**North
Atlantic**

Seabrook Station
Administrative Addendum to the
Seabrook Station Updated Final Safety Analysis Report, Revision 7

CHANGE INSTRUCTIONS (ADDENDUM)

**UPDATED FINAL SAFETY ANALYSIS REPORT
(UFSAR)**

Figure 15.5-1 (Shts 1 thru 3)

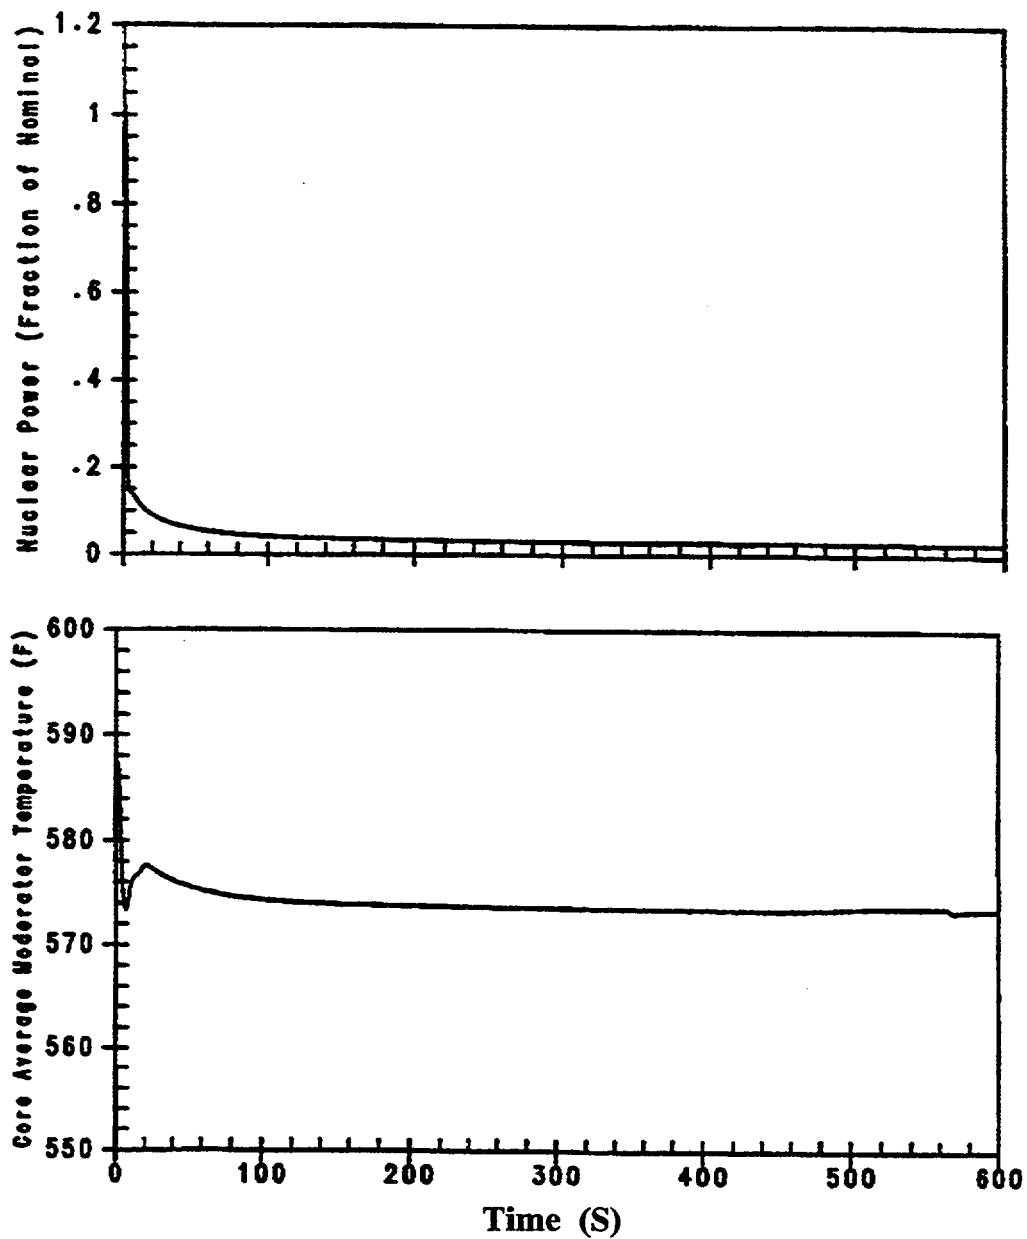
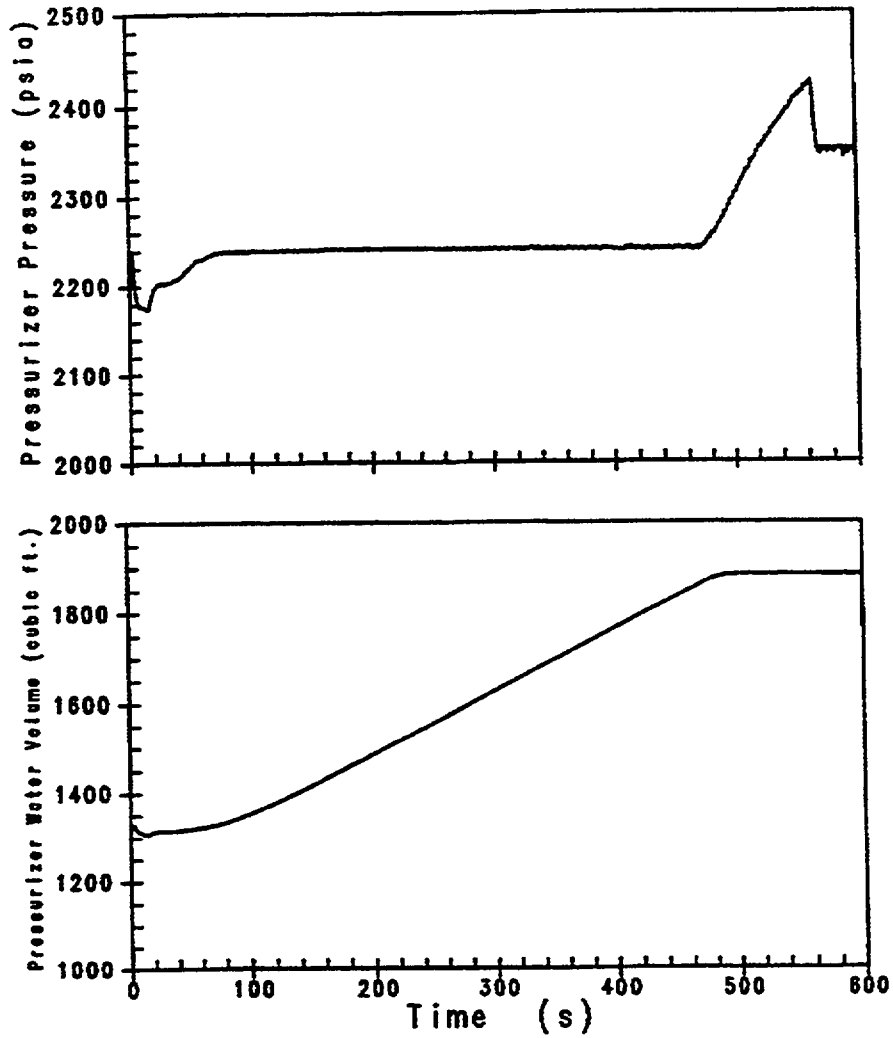
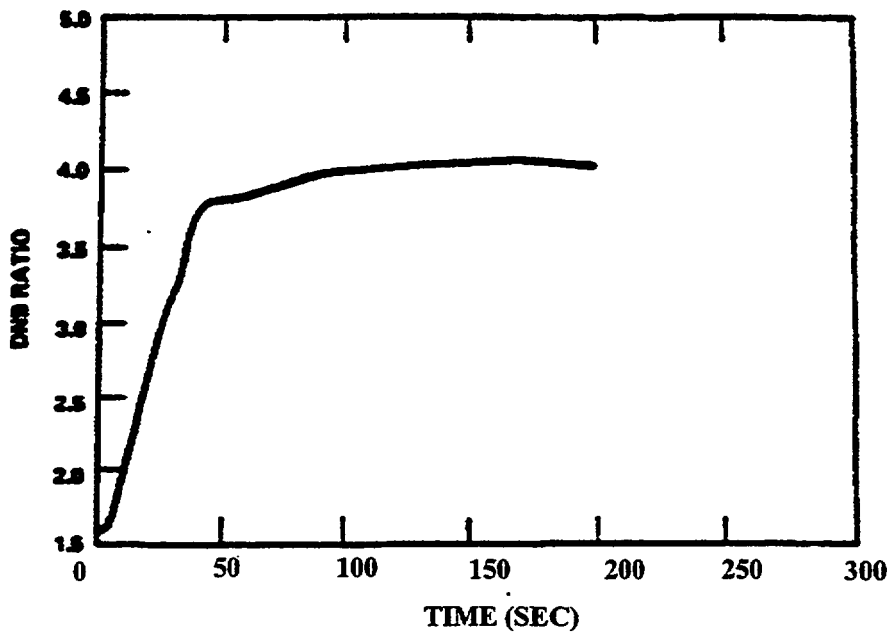
Additional change instructions: After following the change instructions issued with Rev. 7 of the UFSAR, perform the following changes. These changes are a result of photocopying problems and a misidentified Figure.
